Record of Decision

Nyack Gas Plant Site

Operable Unit No.1

March 2004

Figure 3
Extent of Contamination

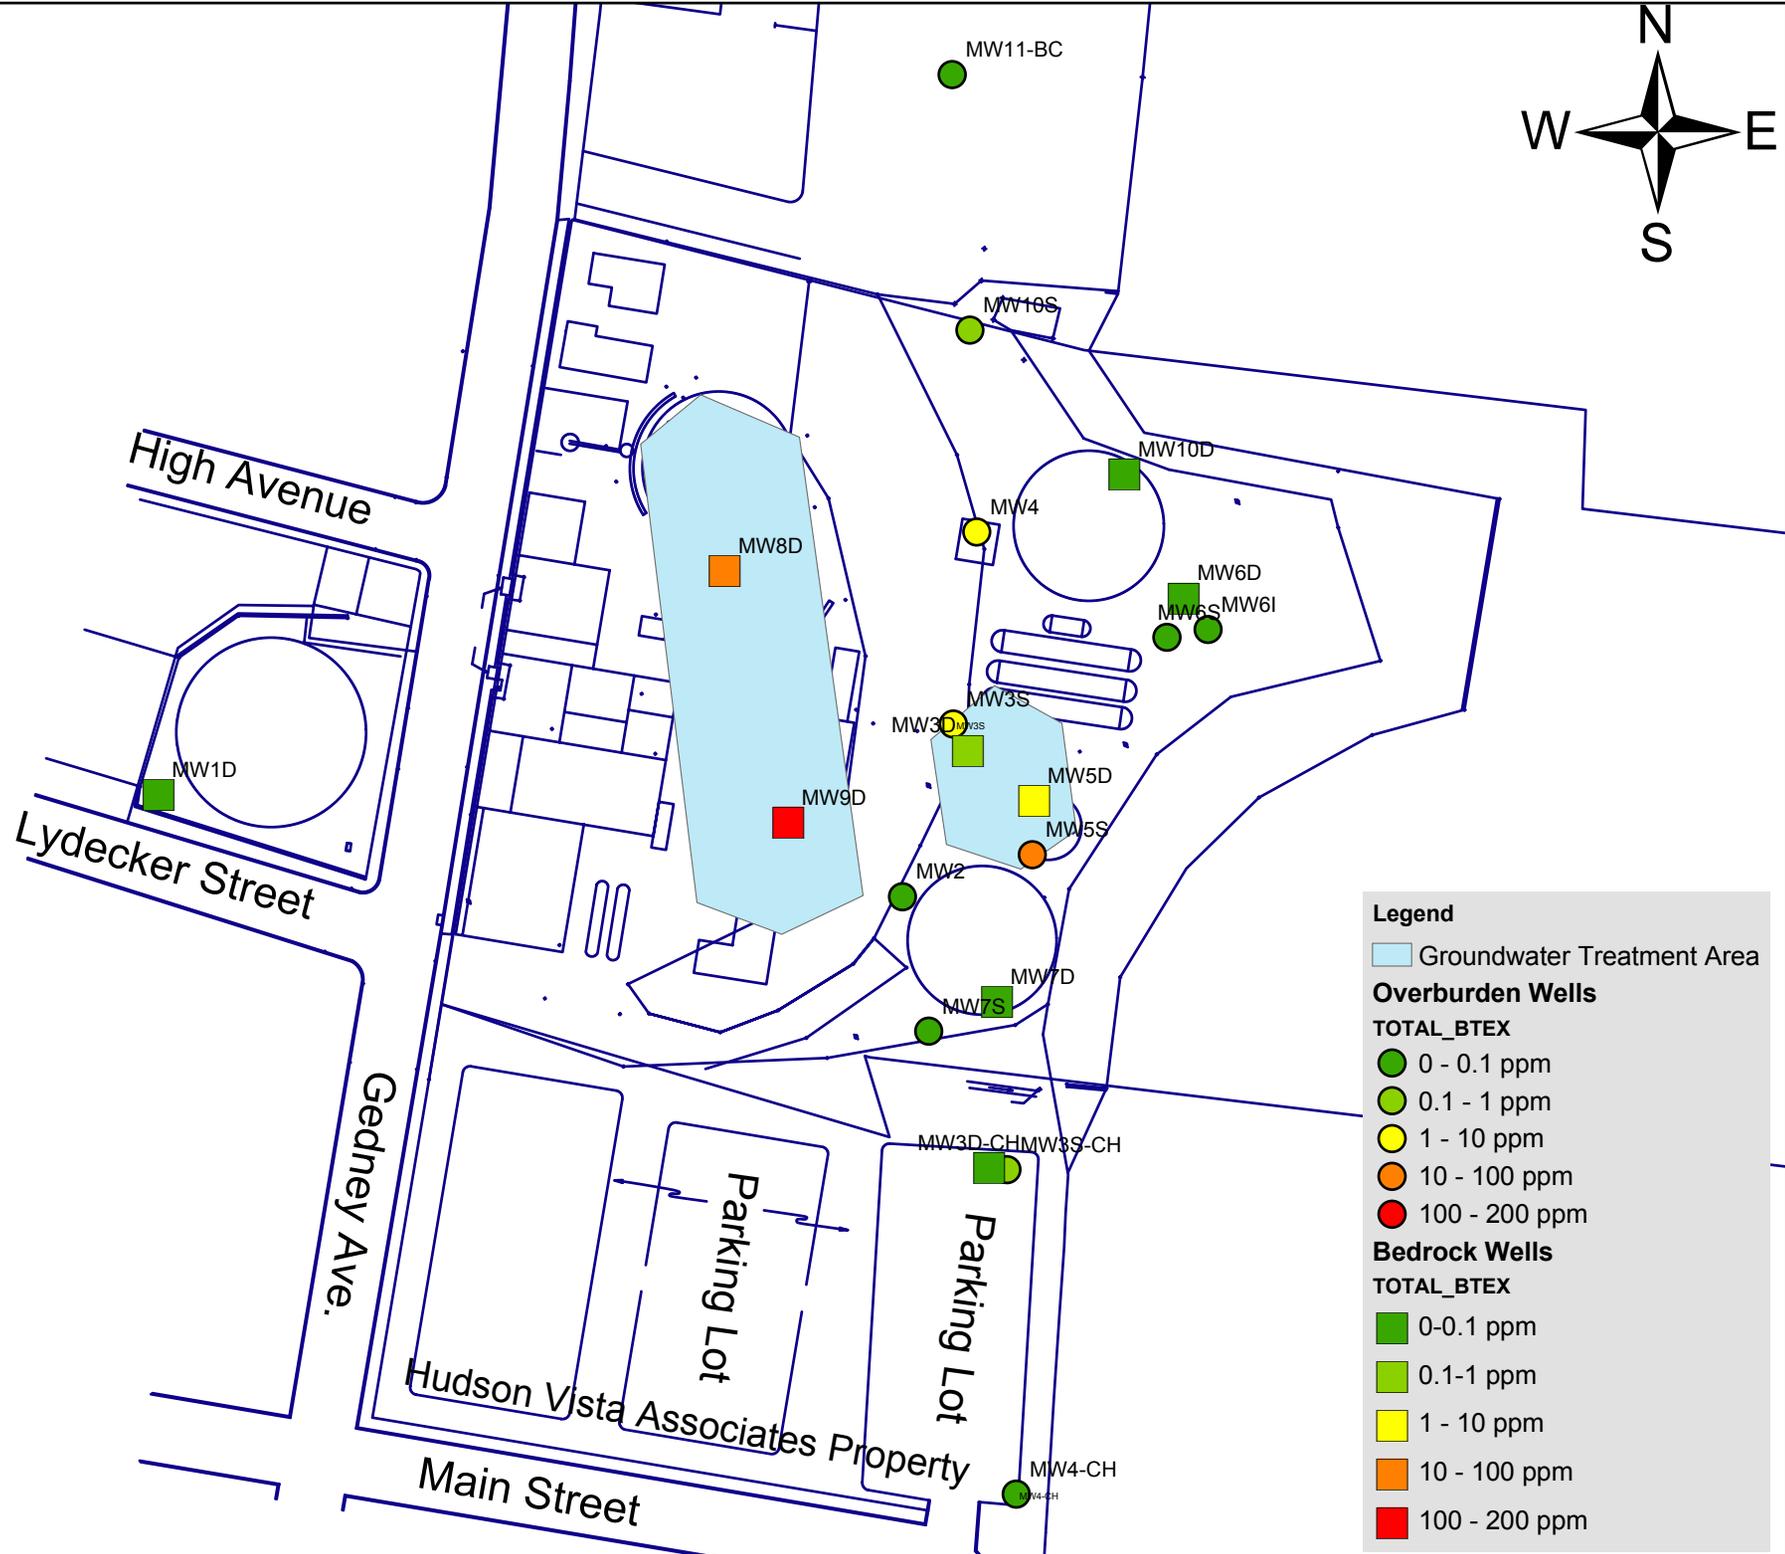
COMMENT 44: It is difficult to determine by the figures in the PRAP if the extent of soil and groundwater contamination have been defined to TAGM levels and groundwater standards, respectively. The contaminant levels on Figures 3 and 4 are represented as ranges, therefore, it is difficult to determine the actual concentrations of each contaminant at each sampling location. Of particular concern is that no sampling appears to have been conducted on the west side of Gedney Avenue at its intersection with High Avenue. I respectfully request that the actual concentrations at each sampling location be provided to the public. If these data indicate that additional sampling, including new monitoring wells and soil borings, are required to fully define the extent of contamination, I respectfully request that the soil and groundwater contamination be fully defined and remediated and that any proposed work to do so be made available to the community.

RESPONSE 44: The actual results of each sampling point are provided in the Remedial Investigation Report, which is in the document repository. This report defines the nature and extent of contamination at this site. Based on a full review of this data, additional investigation work was called for in the ROD. The additional investigation includes work on the west side of Gedney Avenue; soil borings south of High Street, and soil gas points both north and south of High Street. No additional groundwater investigation is necessary based on existing data. When the work plan for this work is finalized, it will be added to the document repository, as will results of this investigation. The definition of the extent of contamination and remediation will be further clarified during the design process.
